REA Briefing Sessions 2016

Part 3 – Common Non-compliance Item in Statutory Submission

Part 3 – Common Non-compliance Item in Statutory Submission

Form EE-LG Submission Poor Submission Drawing Quality

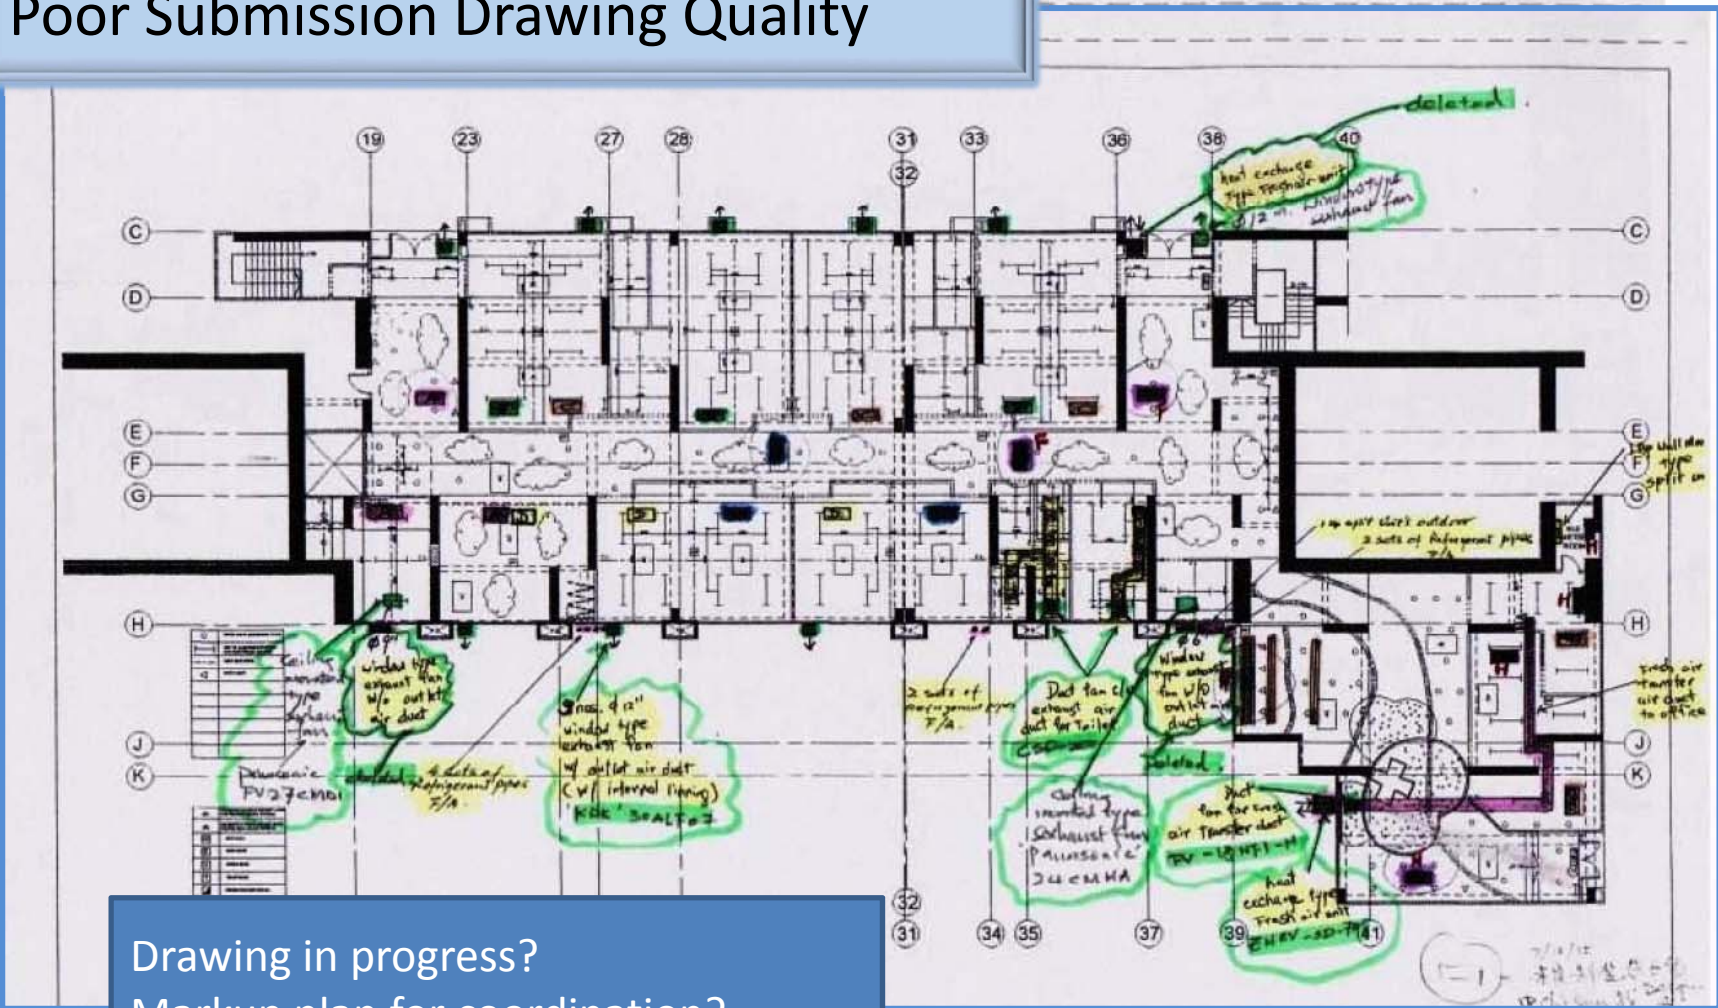
Drawing in progress?
Markup plan for coordination?
Proper as-fitted drawing expected

Lighting Zones

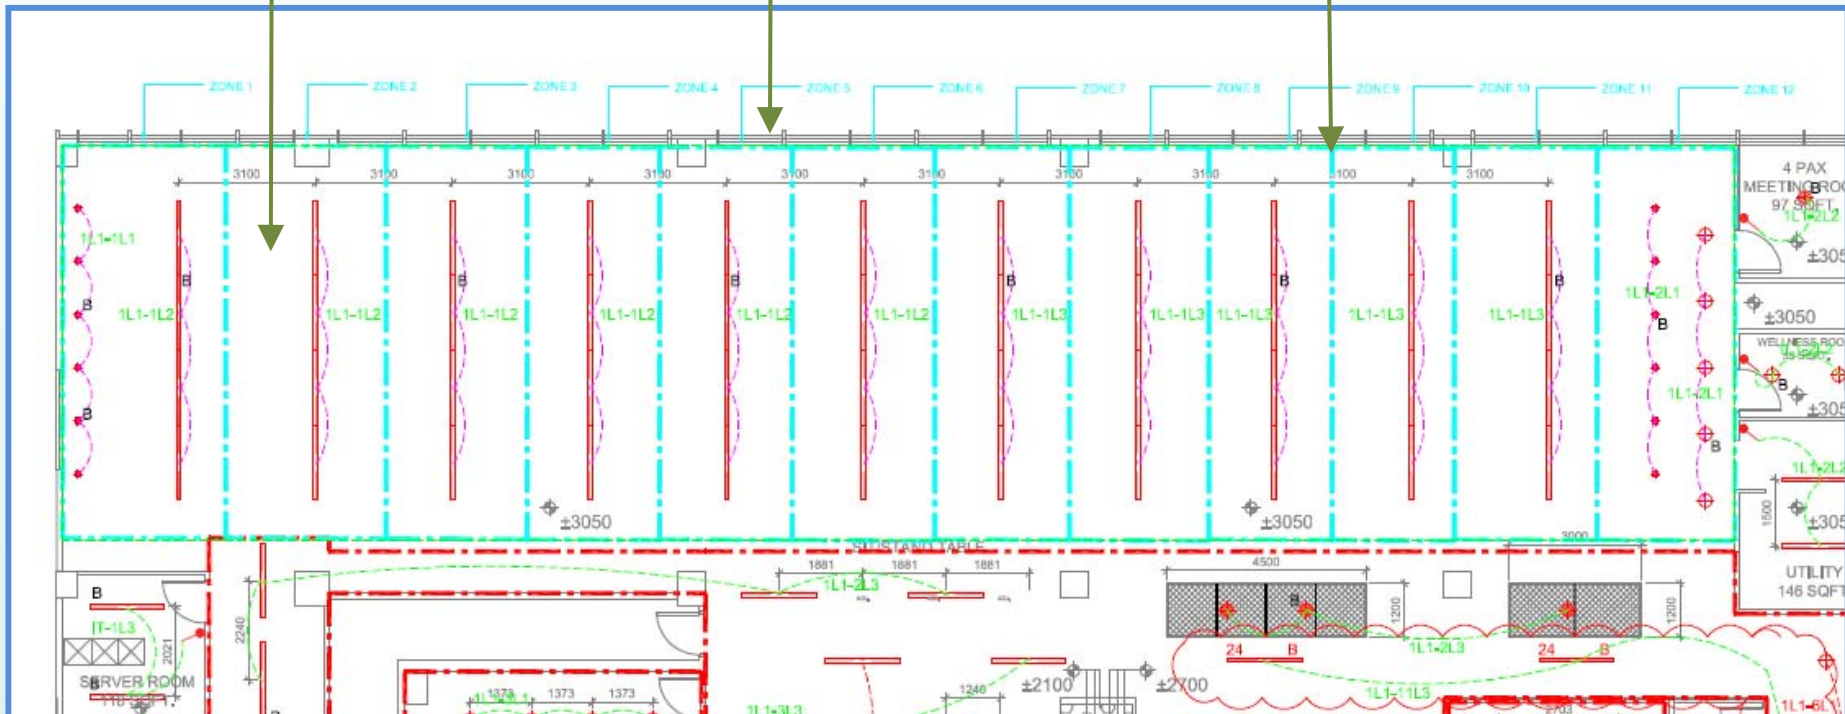
- Small enough LZ
- < 150W in each zone
- → Daylight responsive control N/A??

Please go for proper design !!
